Economic and Social Council

World Forum for Harmonization of Vehicle Regulations

Working Party on General Safety Provisions

Report of the Working Party on General Safety Provisions on its 100th session (11–15 April 2011)

Figure 1, amend as follows :

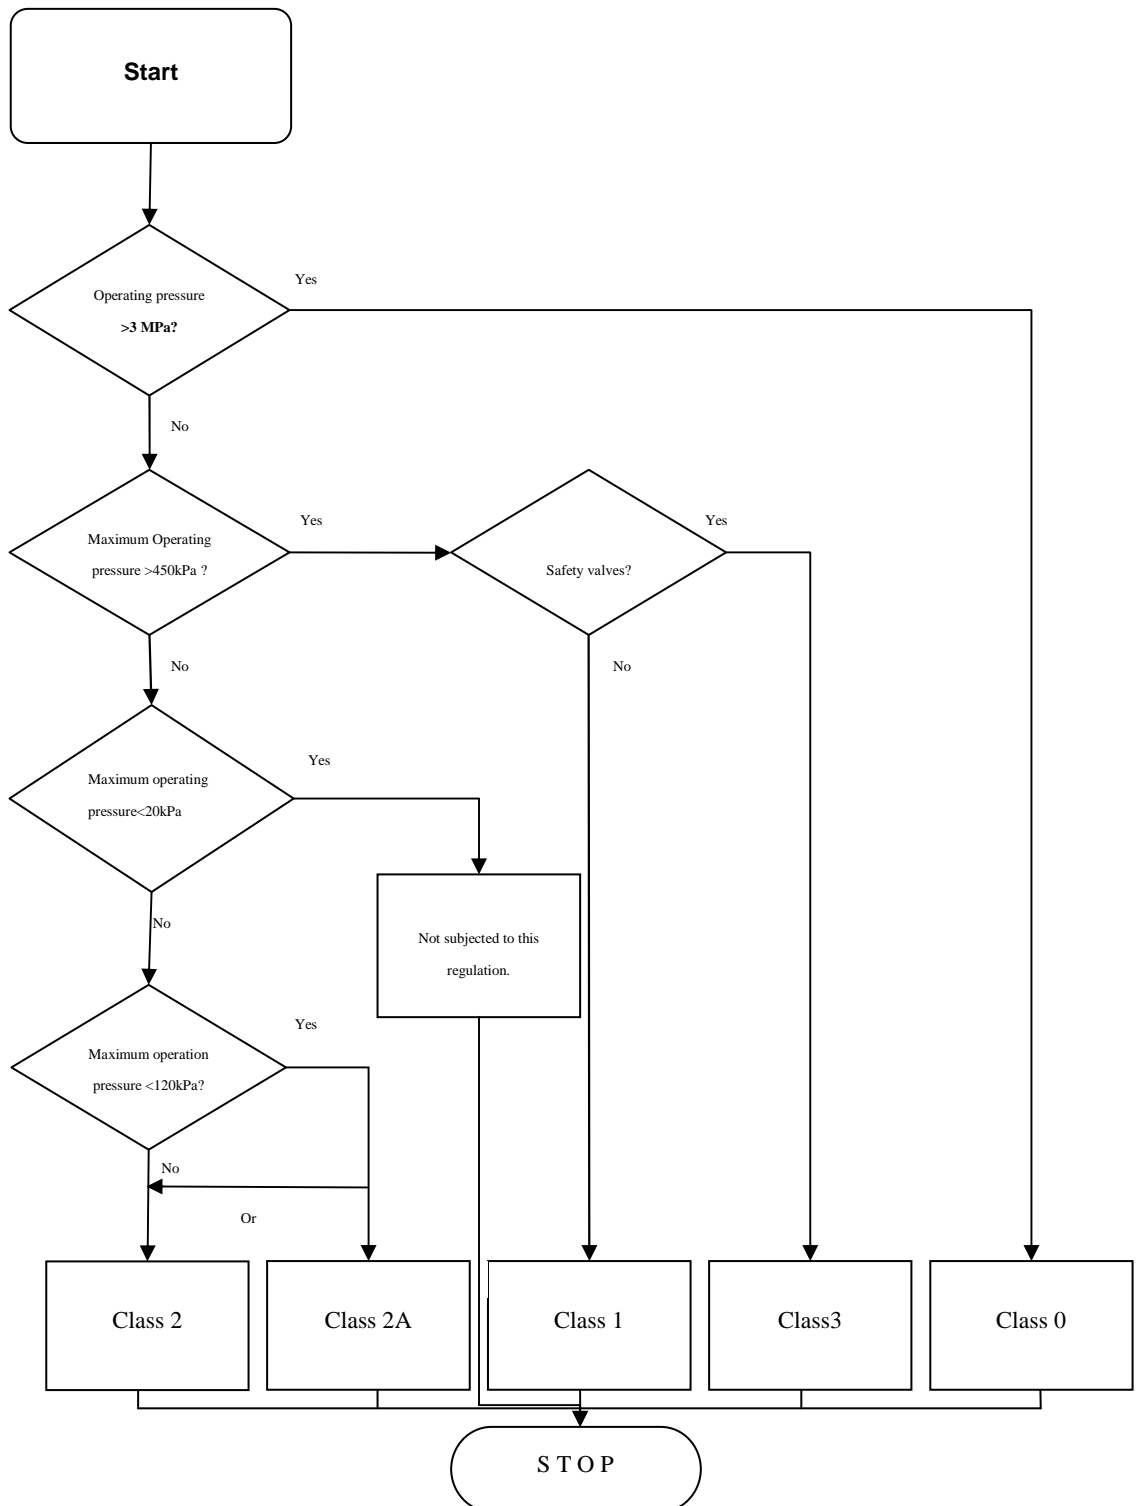
Paragraph 2, amend the text to read:

"Class 0 High pressure parts including tubes and fittings containing liquid LPG with a pressure > 3,000 kPa"
